<p>iAccess Consultants 2/20 BALFOUR ROAD ROSE BAY, NSW 2020 (P) 0408 627 908 (E) r.seidman@iaccessconsultants.com (W) www.iaccessconsultants.com</p>		<p>TITLE: <b>ACCESSIBLE PARKING - PERPENDICULAR LINE MARKING SETOUT</b></p> <p>DWG. No. ###</p>	<p>TECHNICAL SHEET</p> <p>DATE: OCT 2014 SCALE: AS SHOWN STAGE: - DRAWN: RAS TYPE: - REVIEWED: [-]</p>	<p><b>A20</b></p>
--	--	--	---	--	-------------------

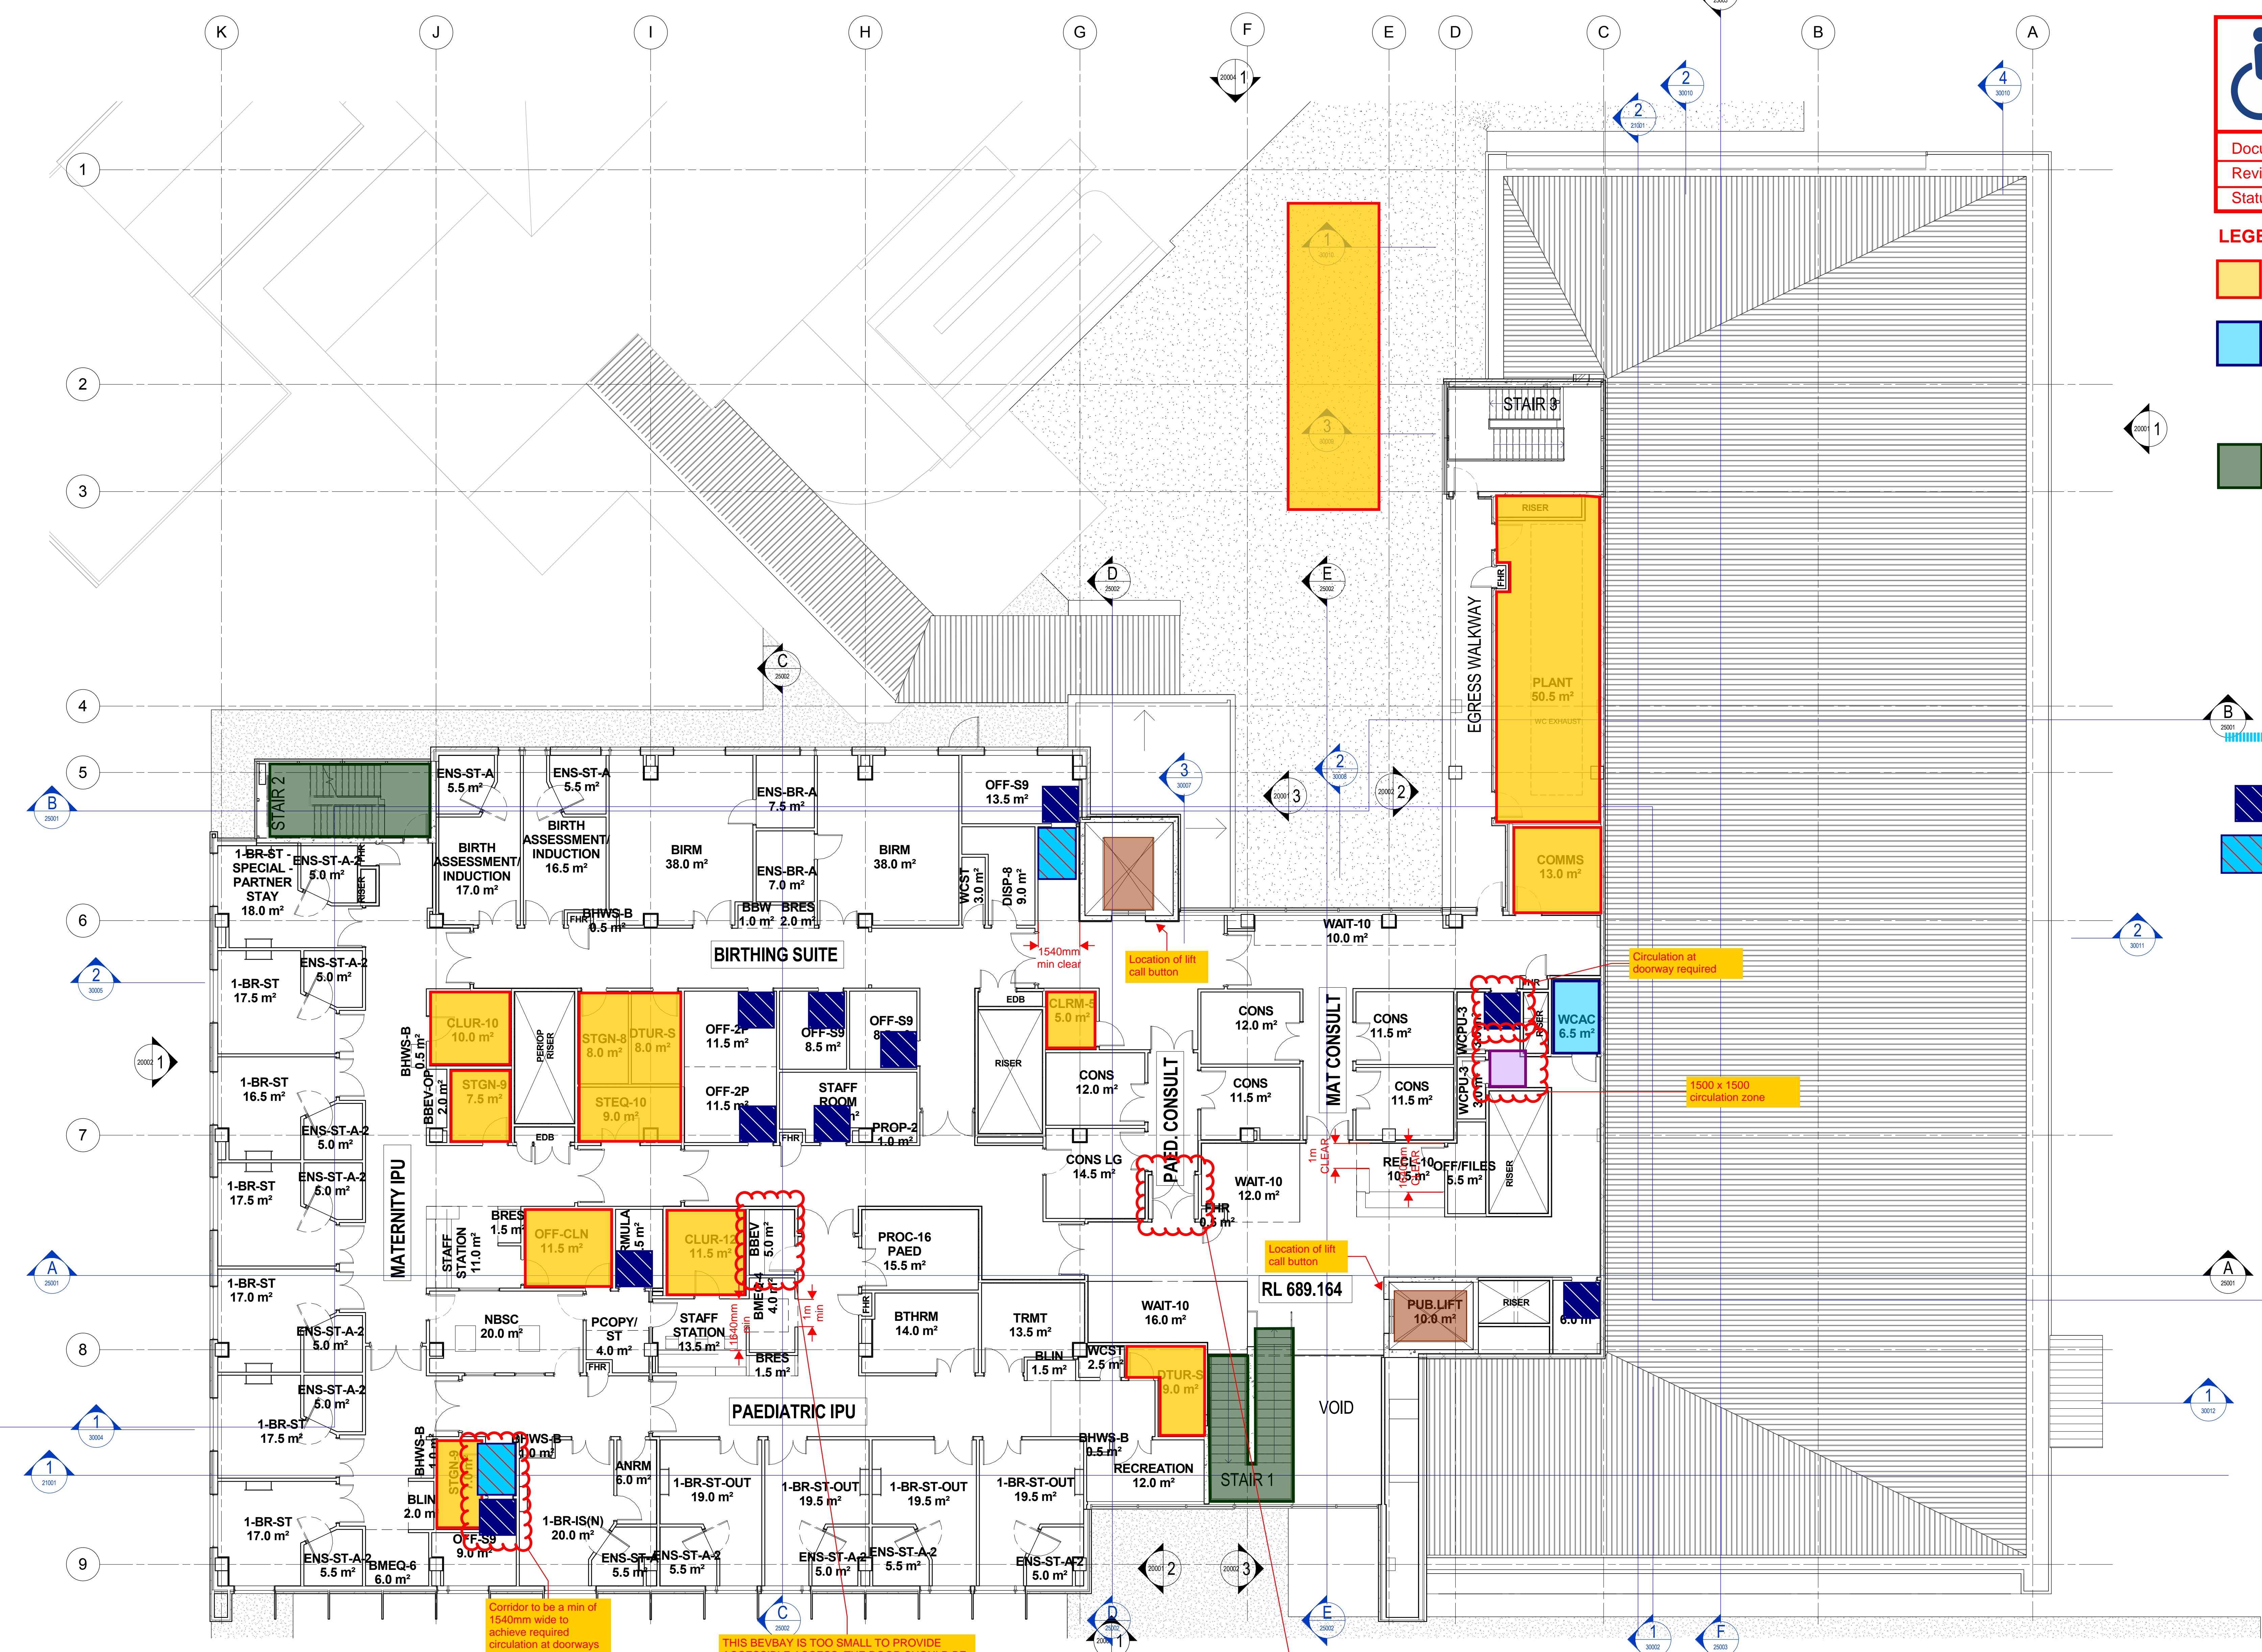
The detailing of this stair will need to satisfy the requirements of Clauses 11 & 12 of AS1428.1:2009. The detailing of the handrails may necessitate the repositioning of the stair. A solid landing will be required to be provided at the base of the stairs. The minimum dimensions of the landing will need to be 1200mm x width of stairs.

The detailing of this stair will need to satisfy the requirements of Clauses 11 & 12 of AS1428.1:2009. The detailing of the handrails may necessitate the repositioning of the stair. A solid landing will be required to be provided at the base of the stairs. The minimum dimensions of the landing will need to be 1200mm x width of stairs.

Provide a level threshold to the external door.
